**Comments of the Natural Resources Defense Council (NRDC) on the
*Inputs to the Energy Demand Forecasts for the 2013 Integrated Energy Policy Report***

Docket Number 13-IEP-1C/1L

March 5, 2013

History of CEC IEPR Forecasts Compared to Actual Electricity Consumption⁴

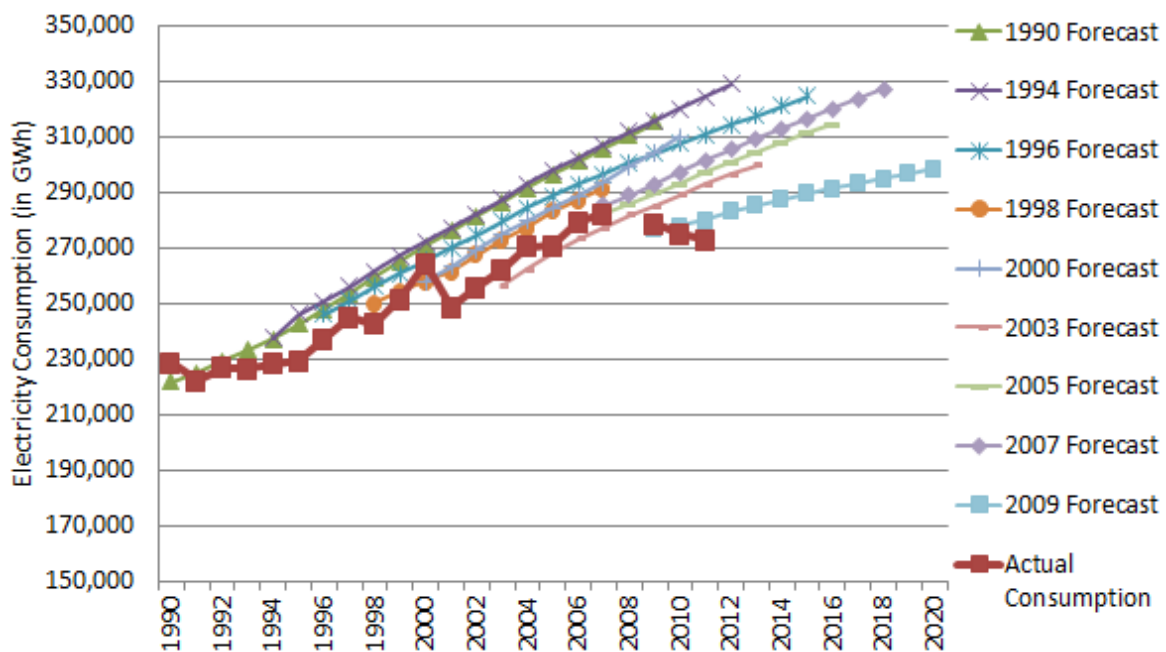
To build an accurate and reasonable forecast, all energy efficiency that is reasonably expected to occur must be included in the adopted demand forecast that is used for resource planning purposes. If the full amount of energy efficiency is not included, then it biases the demand forecast upward. Historically, the CEC's IEPR demand forecasts have not included additional achievable energy efficiency in the adopted base forecast, and correspondingly, have always overestimated what actual demand would be in the long term. That is, in every IEPR forecast dating back to 1990, as published in the 2009 IEPR report—every demand forecast has overestimated the endpoint levels of demand. Here is the history of all IEPR forecasts for which data were published in the 2009 IEPR, and presented alongside actual CEC electricity consumption data.

Every endpoint estimate of electricity consumption is above actual consumption. The long term estimates are important because they are what drive long term investments in resource planning processes. Given that the CEC has always, in every IEPR forecast since 1990, overestimated demand in the long term, it is critical that the CEC set its goal in the IEPR proceeding to create an accurate and reasonable forecast—not a forecast with any upward bias built into it. As part of ensuring an accurate and balanced forecast, we urge the CEC to include the full amount of additional achievable energy efficiency in the reference case demand forecast that is transmitted to other agencies for resource planning purposes.
